# Shire Of Esperance

## Esperance Tanker Jetty Remediation Options Review

### Independent Peer Review

November 2016

TYPICAL STRINGER SPLICE DETAIL - OPTION 1

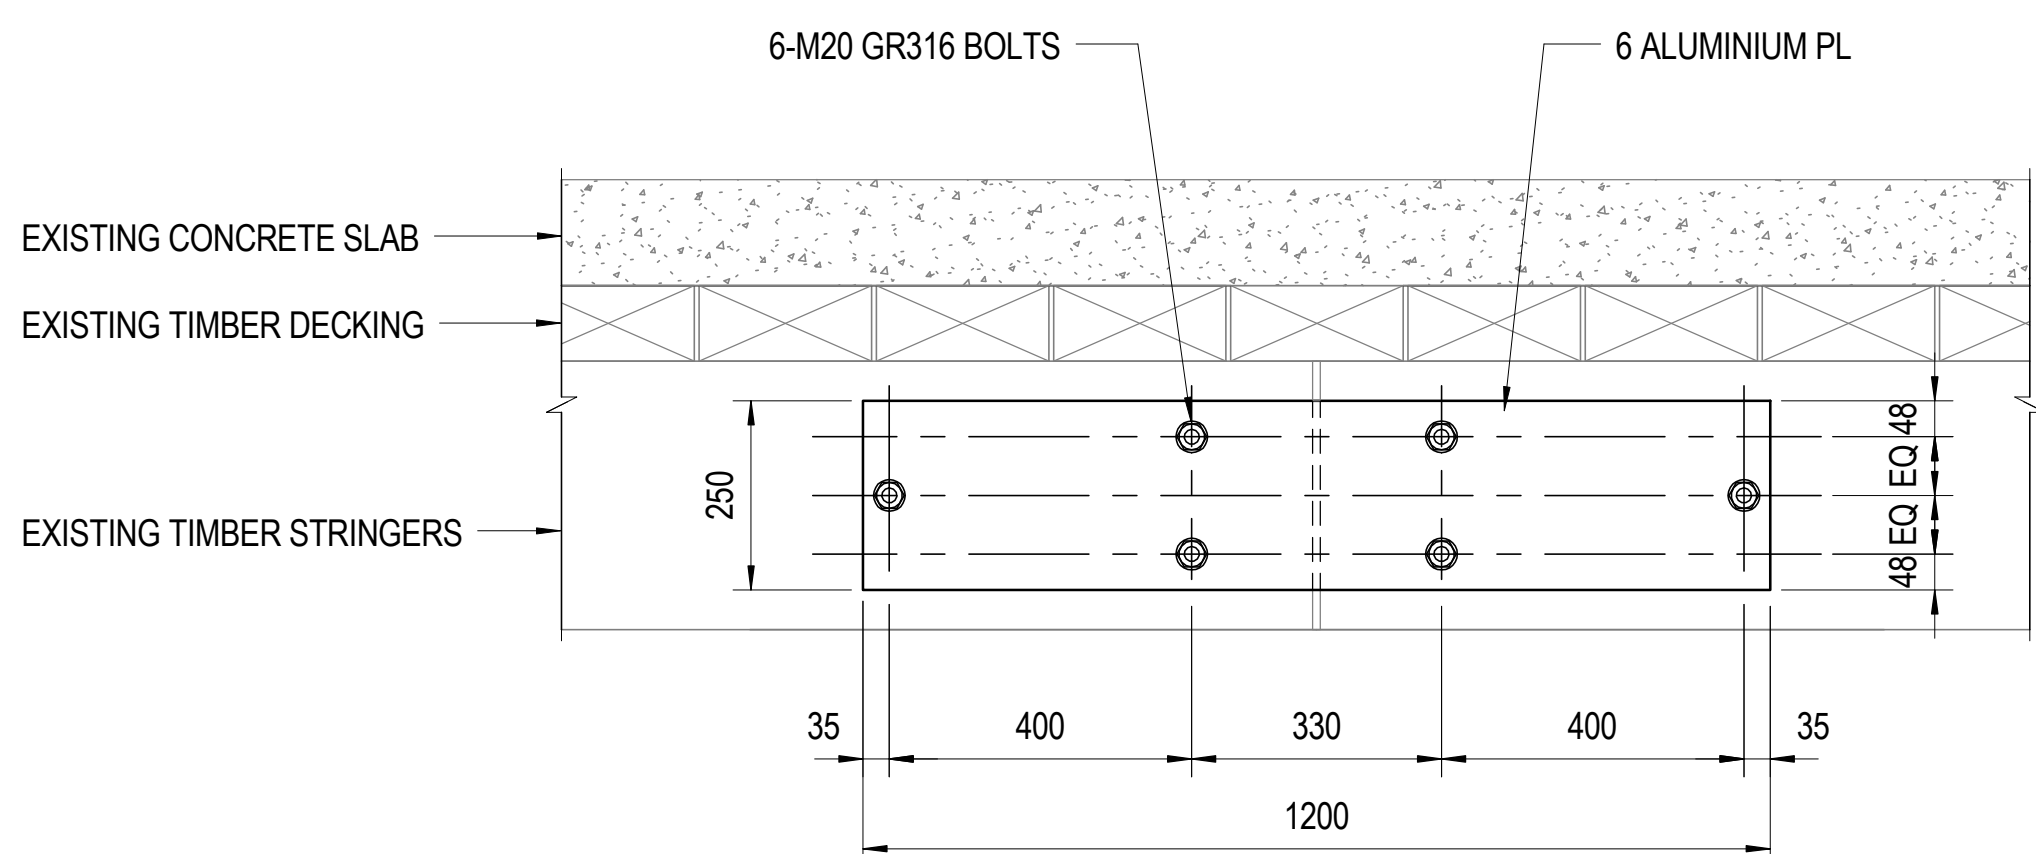
4. In addition to the structural comments outlined in item 3.ii), the splice detail for the stringers is noted as a 6mm aluminium plate with M20 stainless steel bolts. From a durability perspective, aluminium plate may not be ideal for a marine environment and the plate itself is quite thin – confirmation should be provided that all steelwork (including aluminium) will comply with corrosion protection requirements for a 50-year service life. For example, in this case, with 3mm corrosion, there would be no plate section remaining. In addition, the dissimilar metals of the plate and bolts will need to be managed;

**STAGE 1**  
SCALE 1 : 50

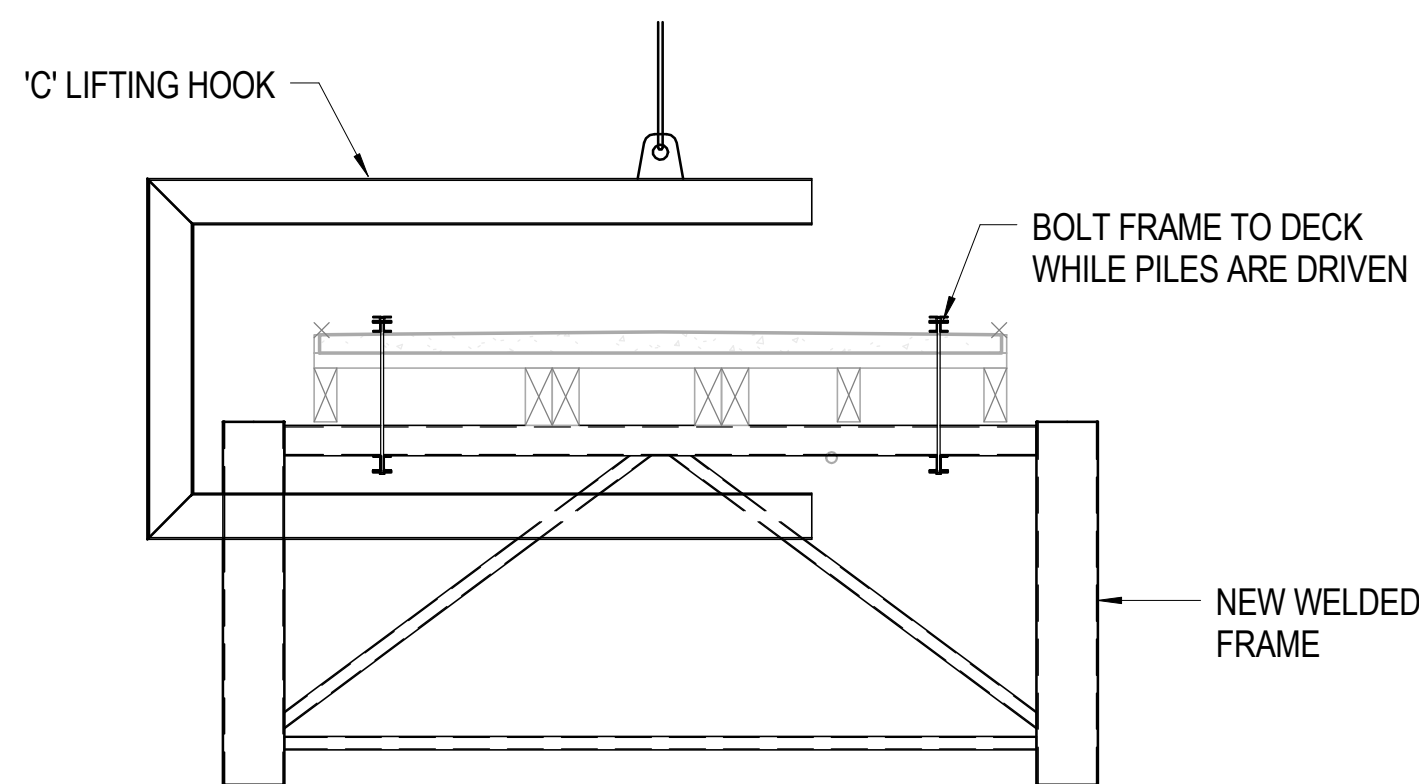
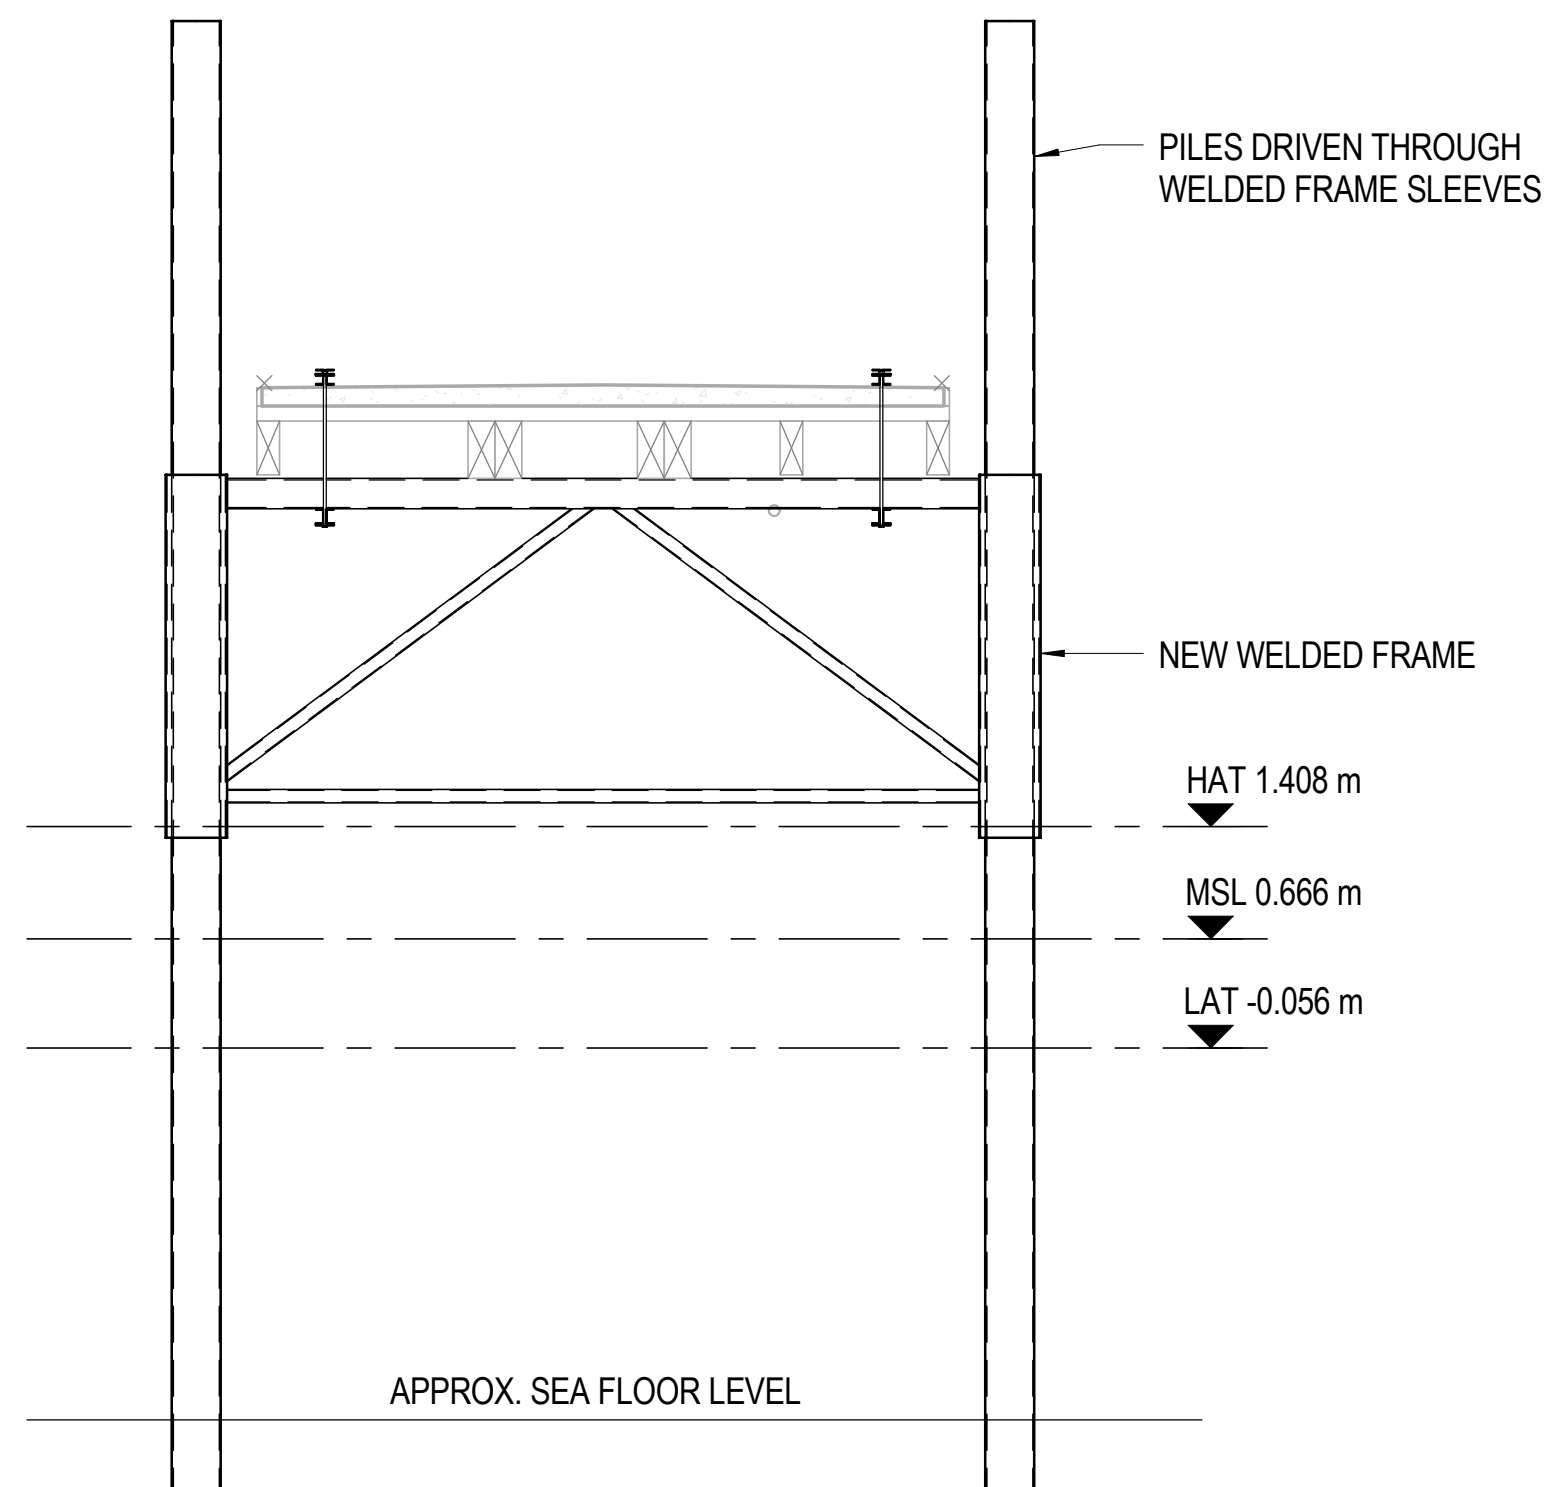
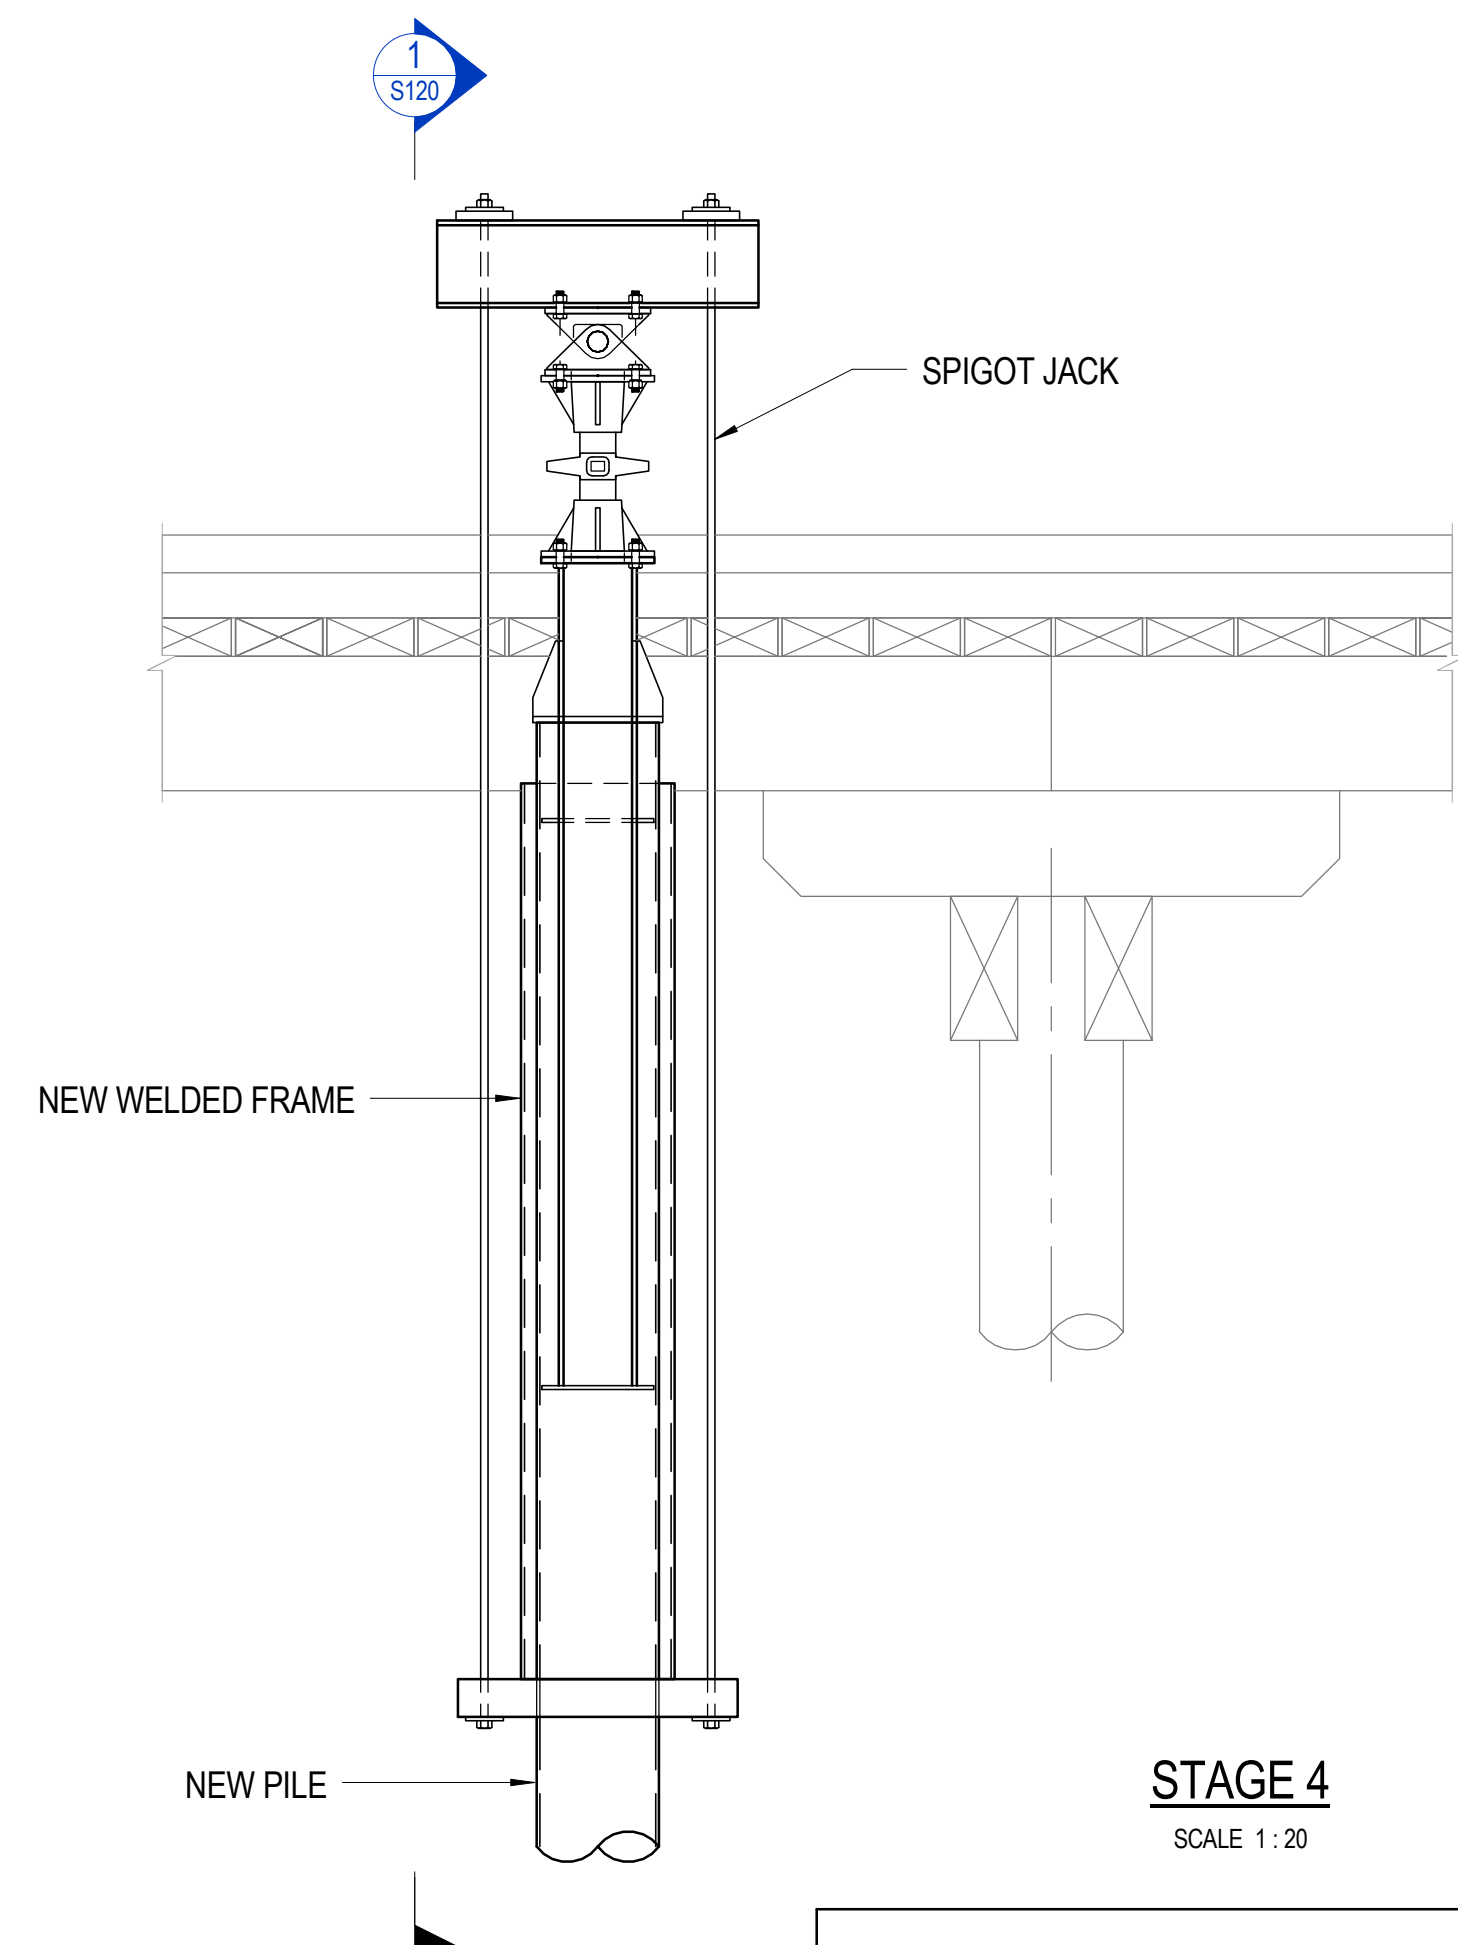
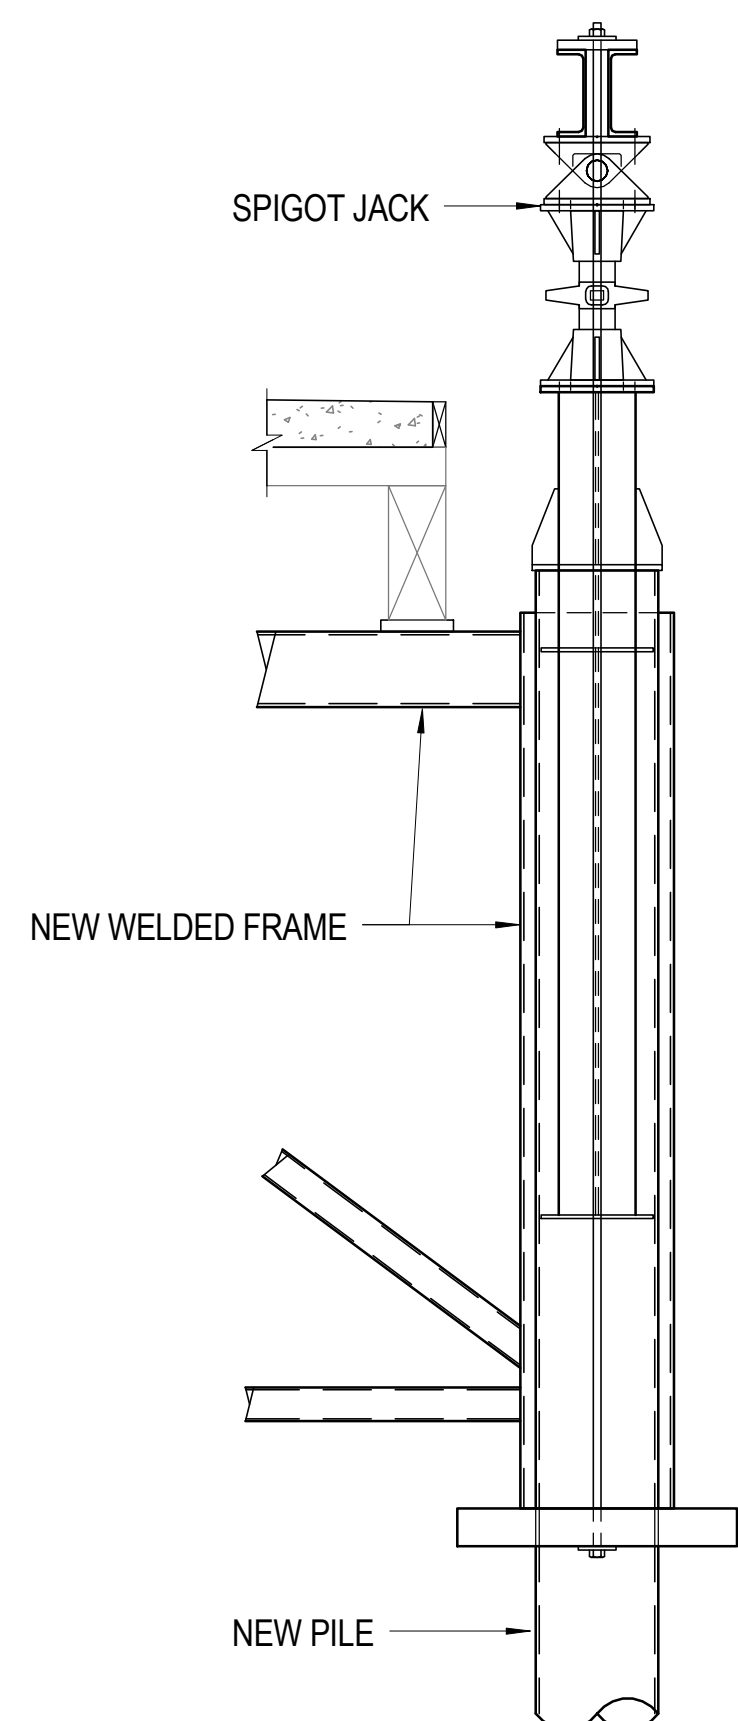
6. The pile installation for both vertical and raked piled will need to be via a barge or water based plant as the existing deck is unlikely to support the construction loads;
